Change Order #1

Project: Academy of Alameda (Chipman) Playground Structure and ADA Upgrades

Date of Issuance:
06/17/2020

DSA App Number:
01-119030

***SEE EXHIBIT ATTACHED SHOWING EXTENT OF WORK AS HIGHLIGHTED

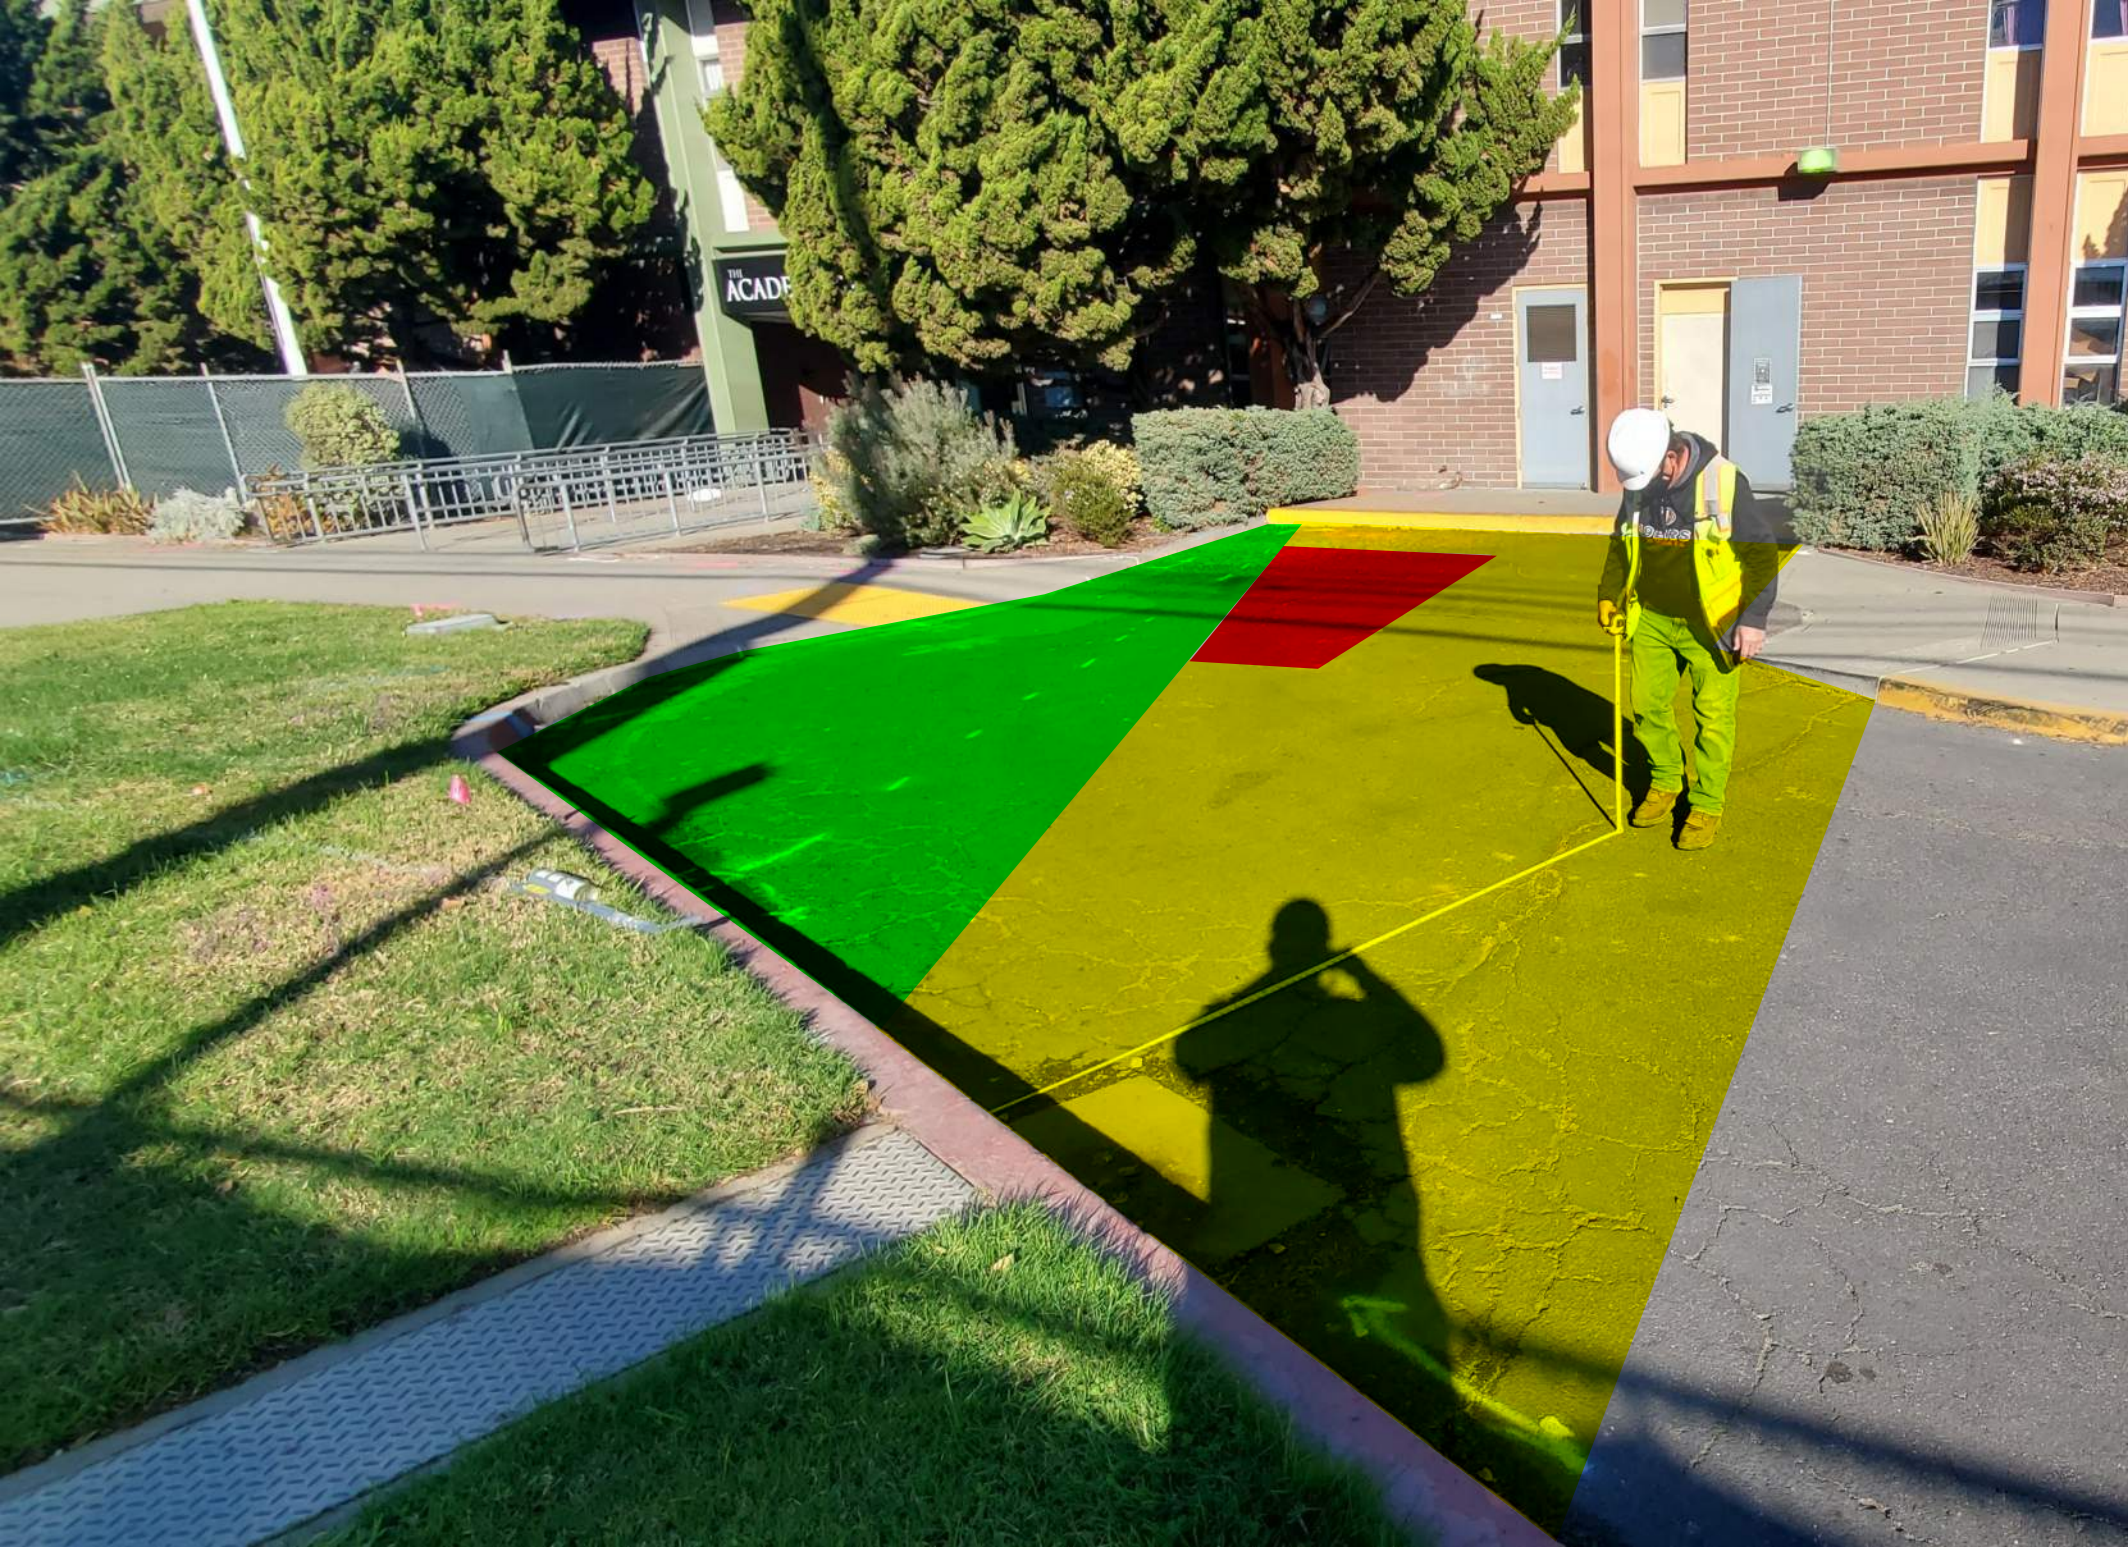
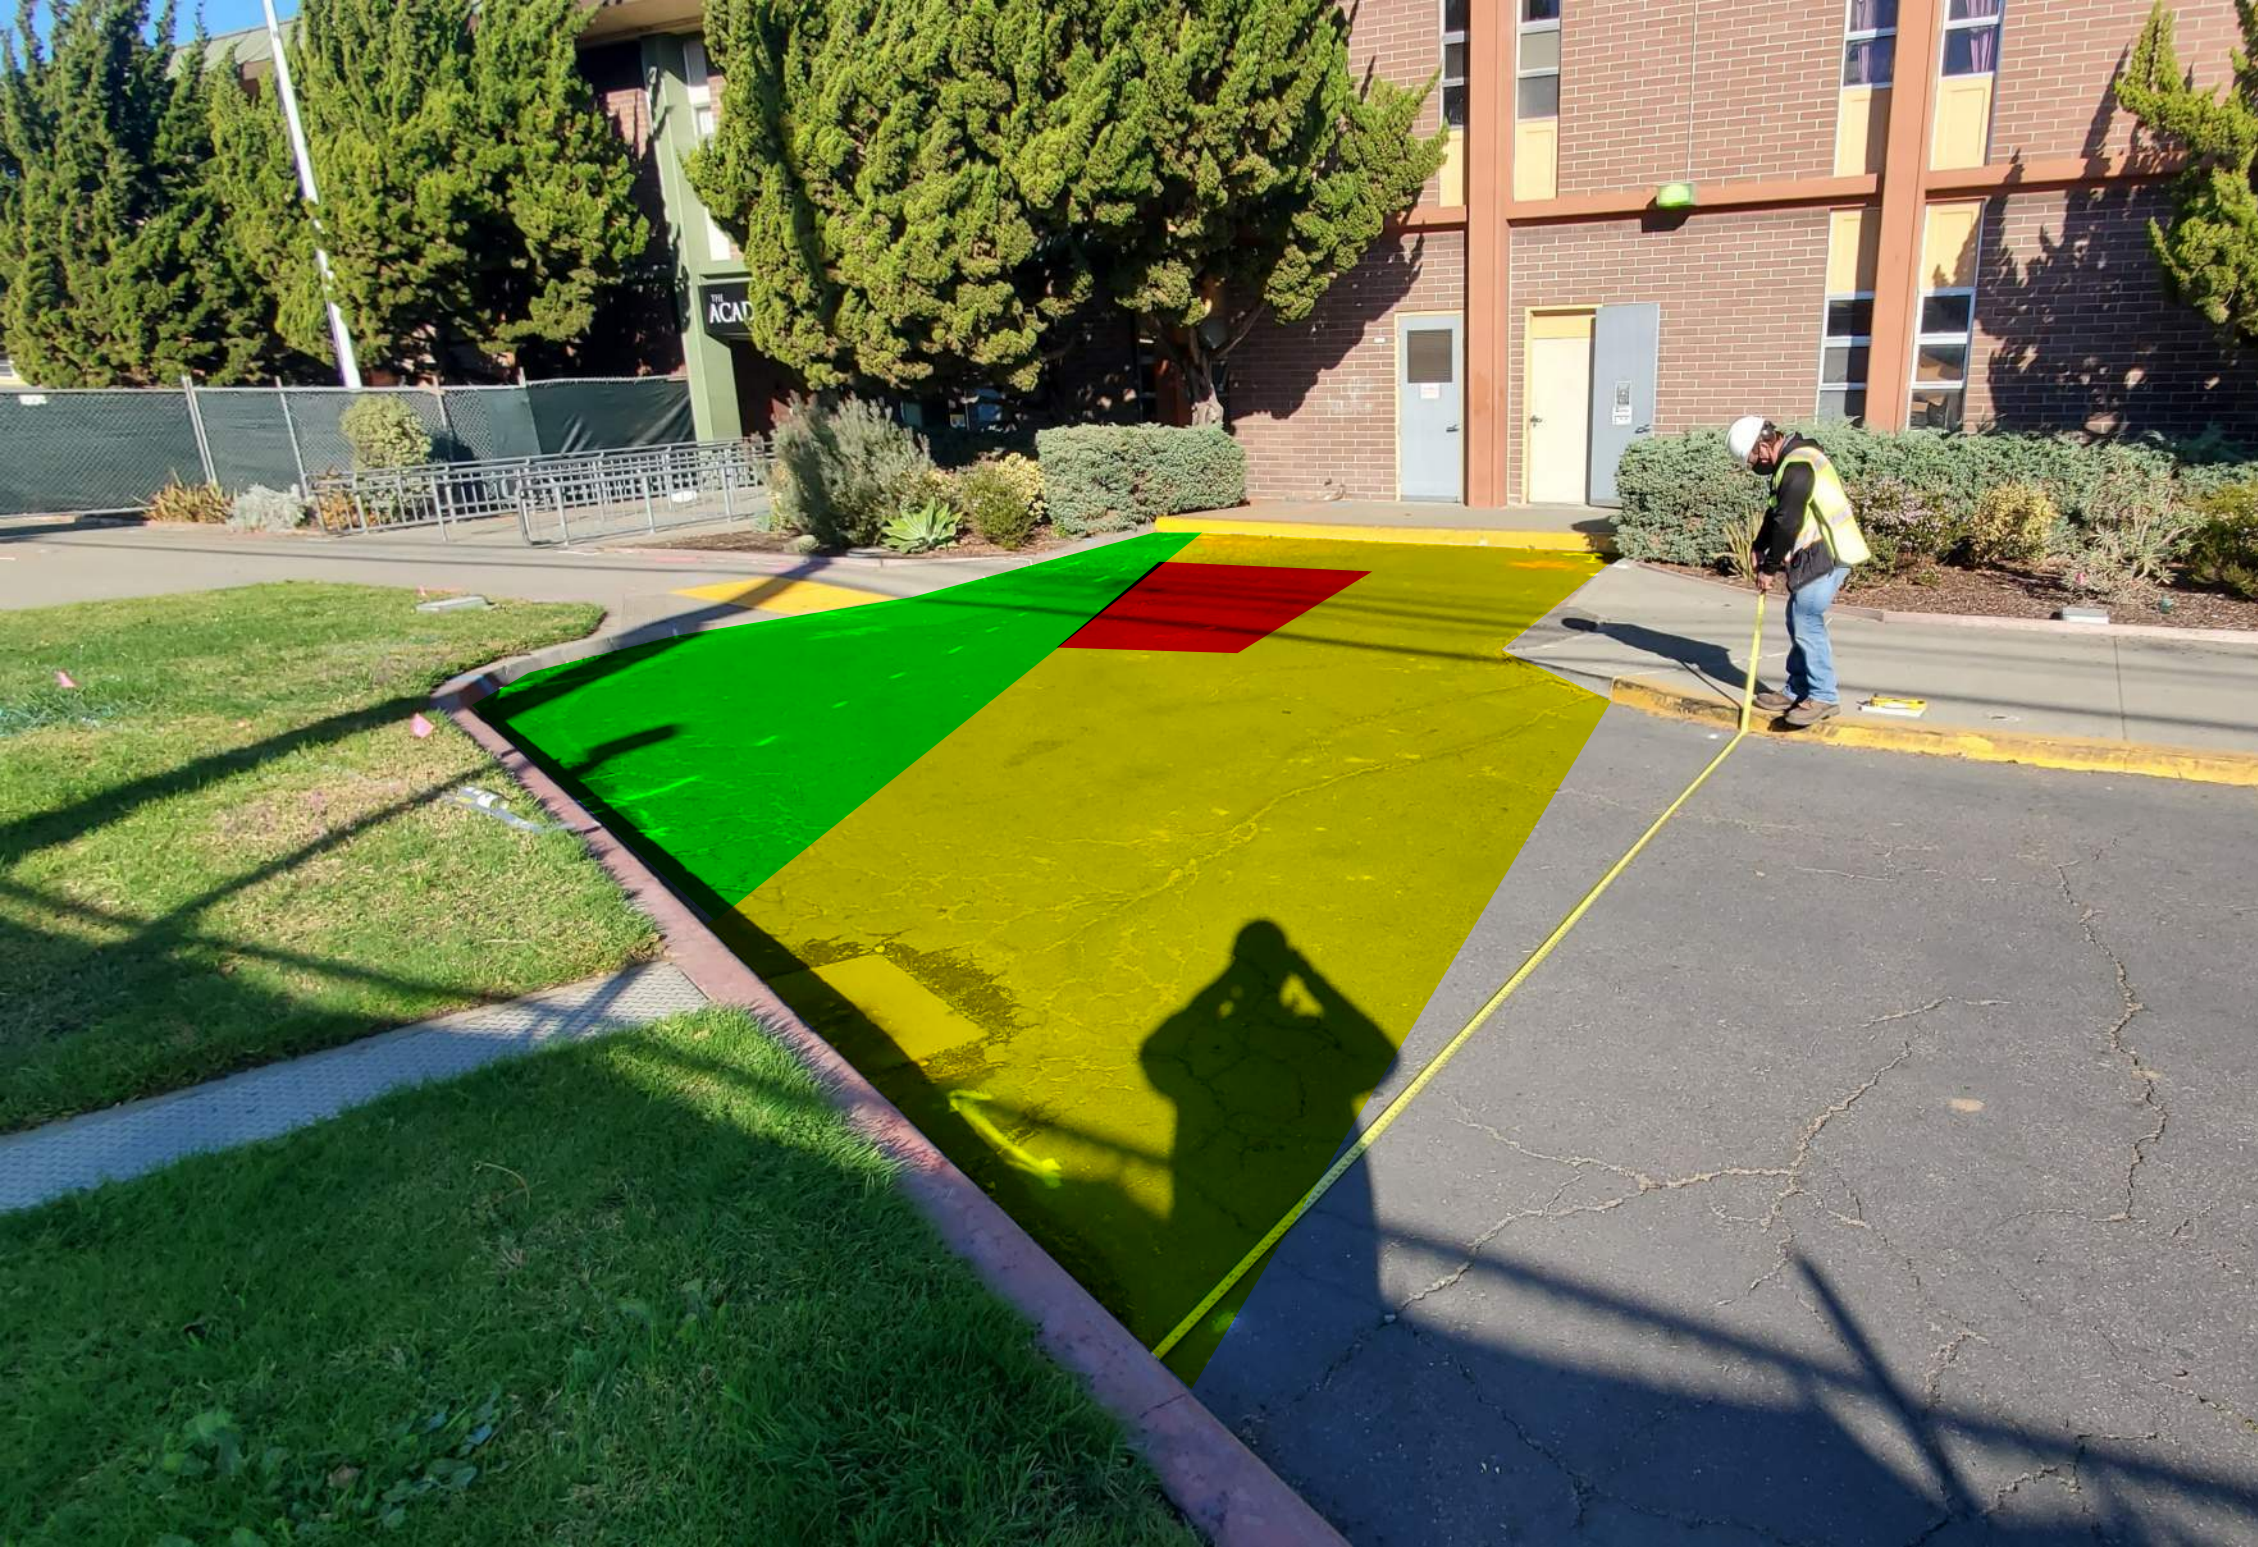
Option #2: Remediate ~530 sqft of broken asphalt. Includes demolition, grading, asphalt.

LOCATION	Scope: As per plans dated 5/26/2020, specifications and addendum #1	\$ PRICE
Option #1	<ul style="list-style-type: none">- Sawcut and remove existing asphalt. 94 SQ FT.- supply and install asphalt paving per plans.- this option is not recommended by silicon.	\$3,200.00 OPTION #1: VOIDED
Option #2	<ul style="list-style-type: none">- Sawcut and remove existing asphalt. 531 SQ FT.- Supply and install asphalt paving per plans.	\$7,200.00
TOTAL		\$7,200.00

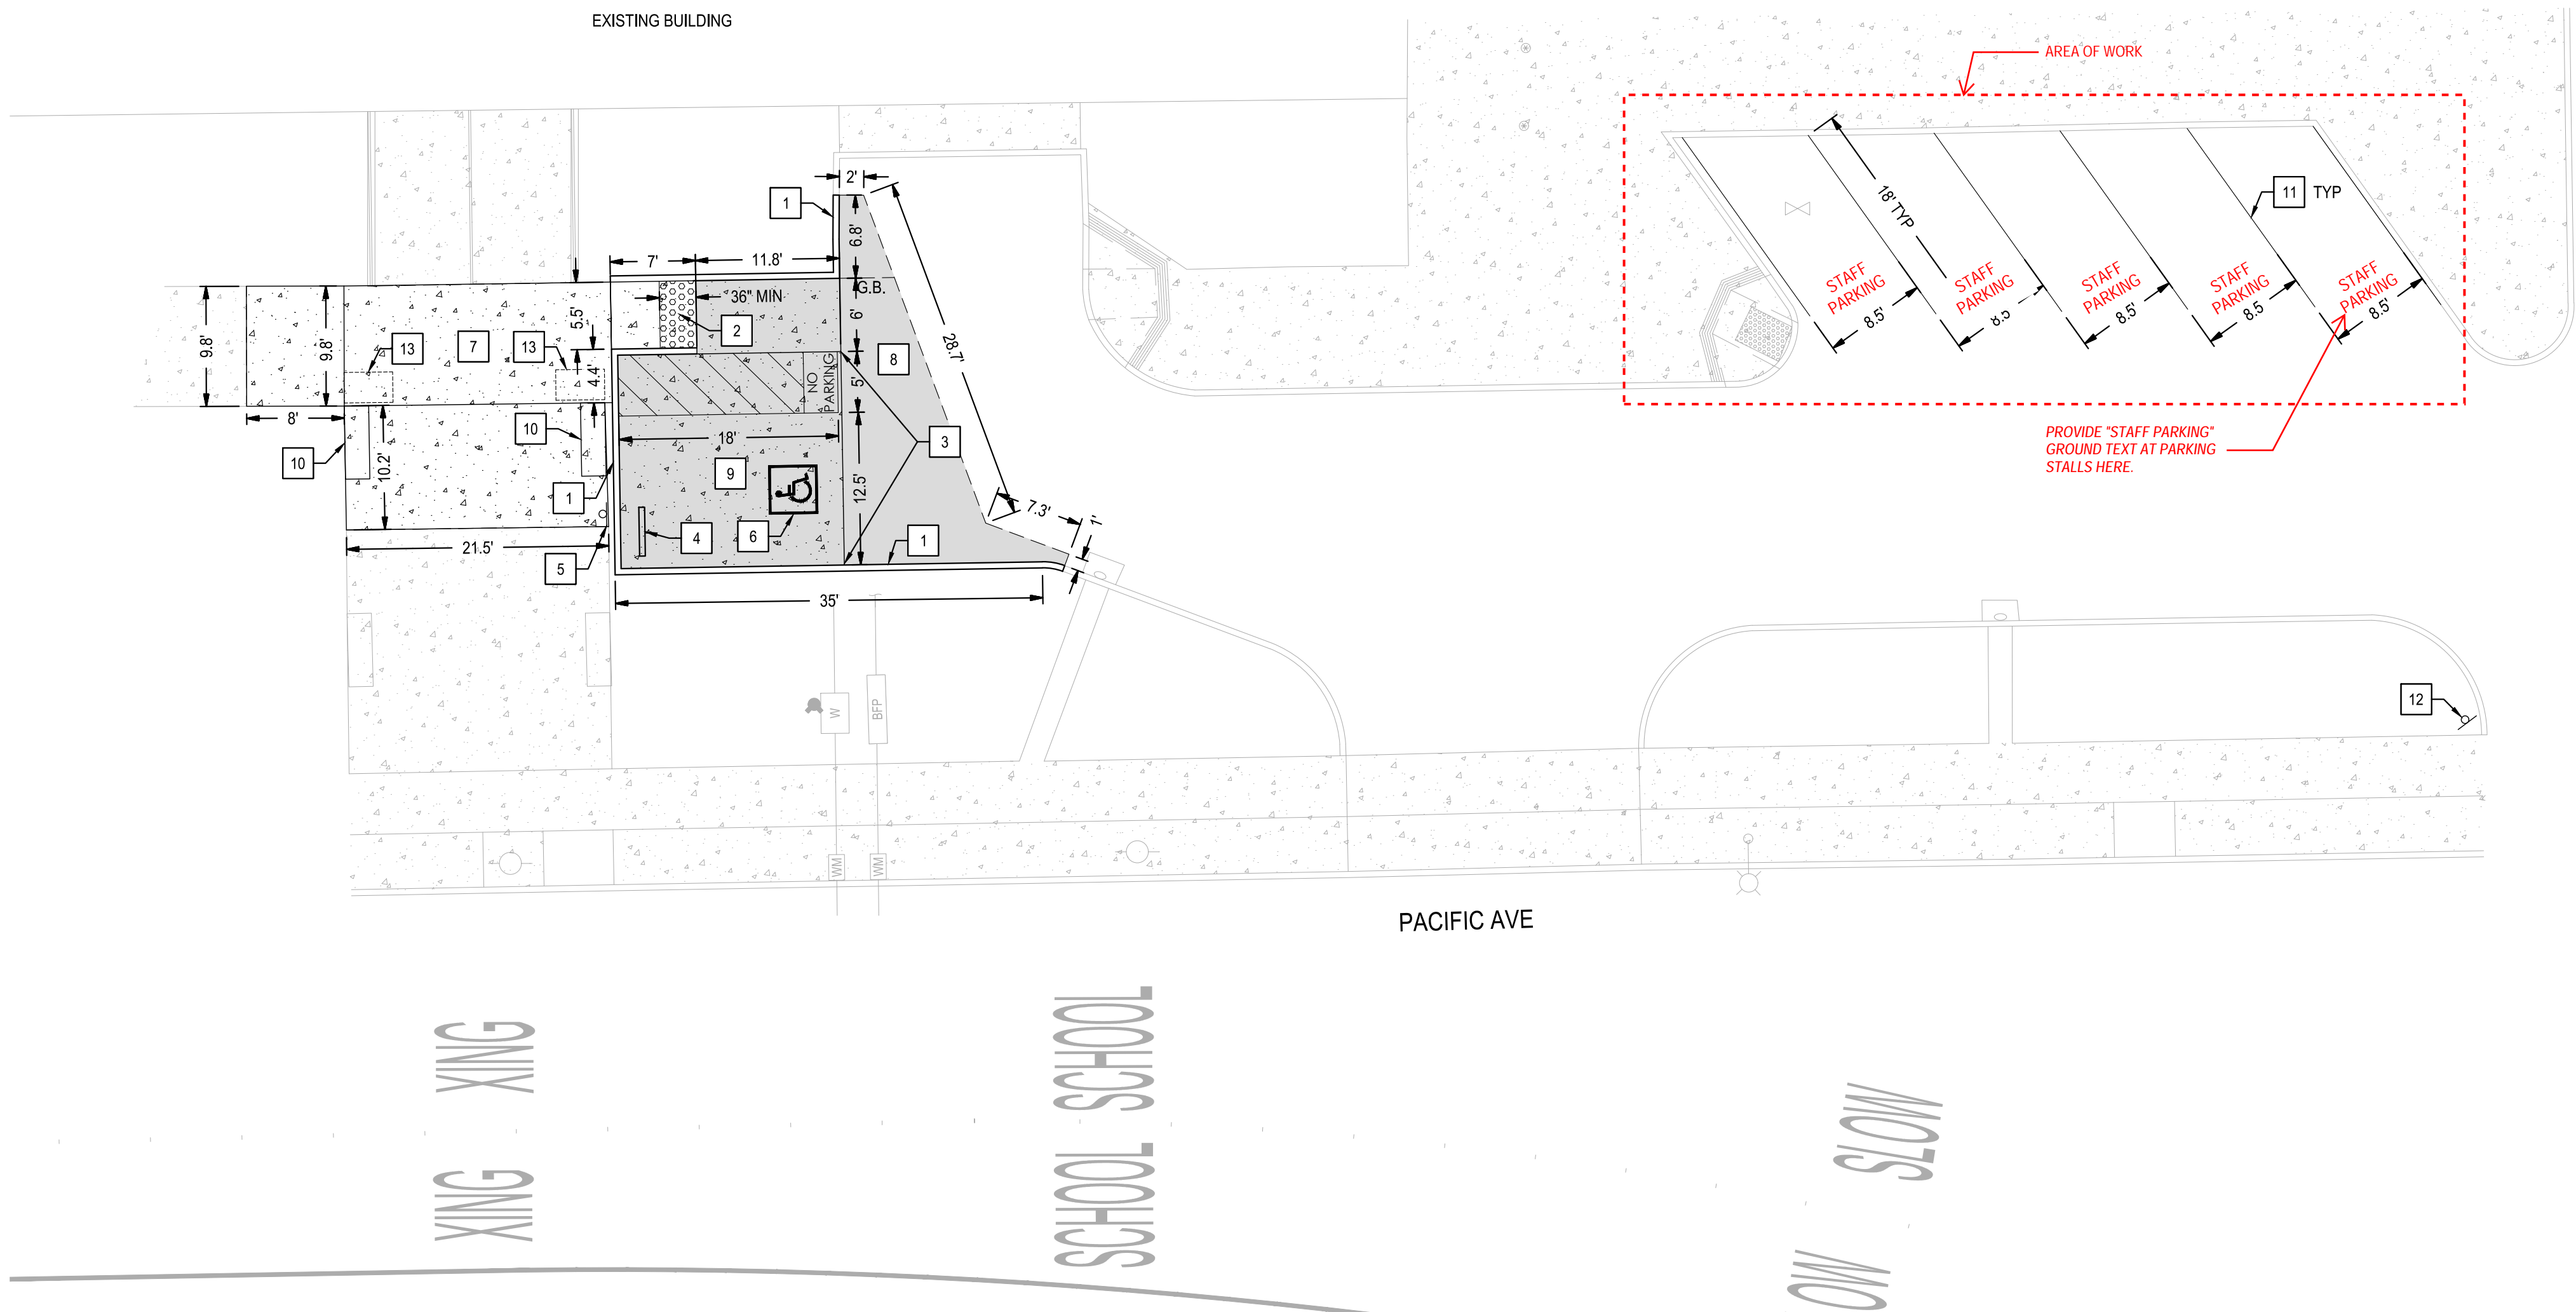
Add "STAFF PARKING" to 5 adjacent parking stalls at front parking lot. Text in white with 12" lettering.

- Paint "STAFF PARKING" in 12 inch letters at 5 parking stalls:
